**GDA close-out for the AP1000<sup>®</sup> reactor**

**GDA Issue GI-AP1000-SI-06 – Structural Integrity Categorisation and Classification**

Assessment Report: ONR-NR-AR-16-013  
Revision 0  
March 2017

Figure 1: AP1000 Plant Steam Generator Support System General Assembly

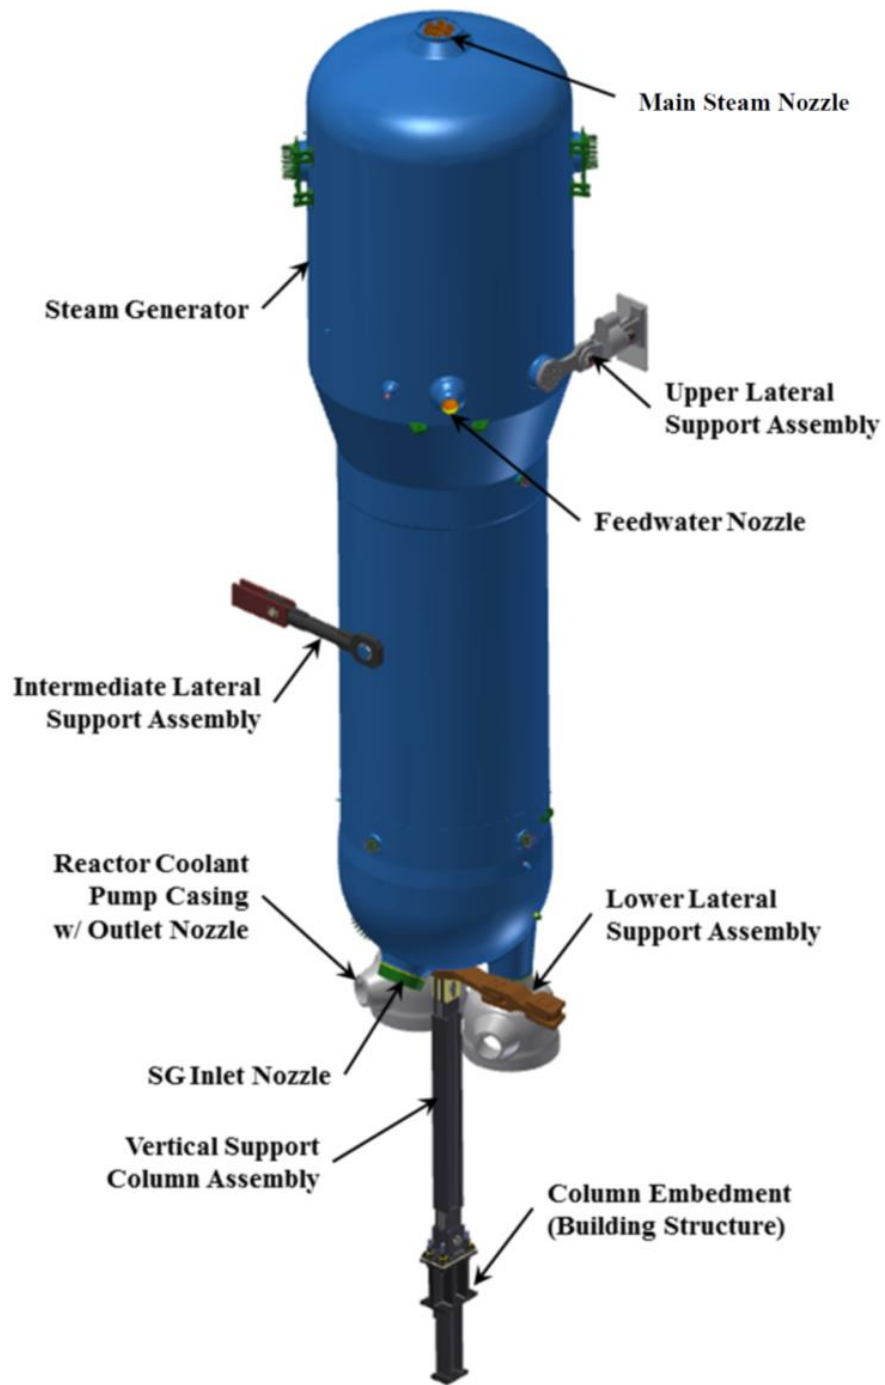
146. In my opinion, the assumption of loss of the SG vertical support column is pessimistic, because, this configuration is most likely to produce maximum vertical displacement of the SG under gravity, potentially causing significant stresses / strains at the hot and cold piping connections. Figure 1 shows that the SG is supported laterally at several

**Figure 2: Reactor Coolant Loop Isometric View**

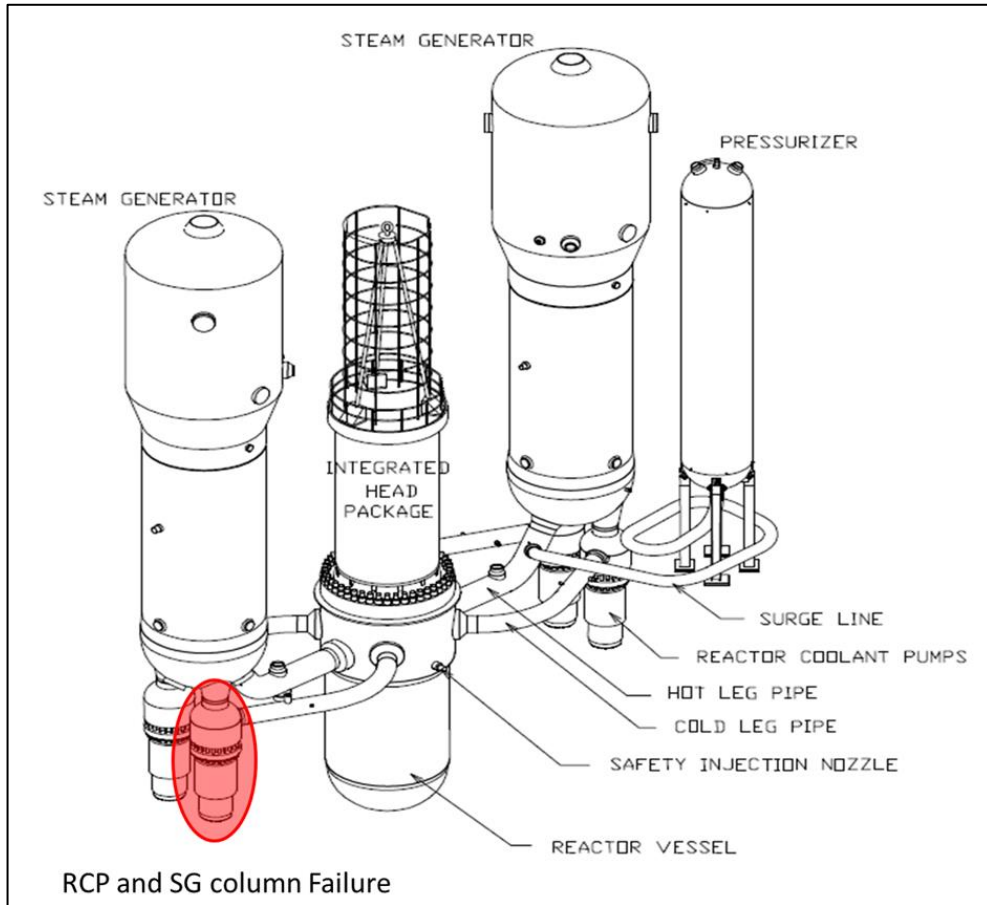
148. The postulated fault occurs when the RCL piping is under normal operating reactor conditions (pressure and temperature). Figure 2 shows that due to postulated disintegration of the RCP casing bowl, the cold pipe connection to the RCP is severed as well as the connection with the SG. This results in thrust forces acting vertically and horizontally due to fast escaping reactor coolant under normal operating pressure and temperature. Further, the postulated loss of the SG vertical support column results in the SG being supported only by the hot pipe connection from the reactor pressure vessel (RPV) and the remnant cold pipe connecting the RPV and the neighbouring RCP bowl casing (Note – each SG is connected to a pair of RCPs). Westinghouse has used the following load cases to determine the structural integrity of the hot and cold RCL piping supporting the SG:
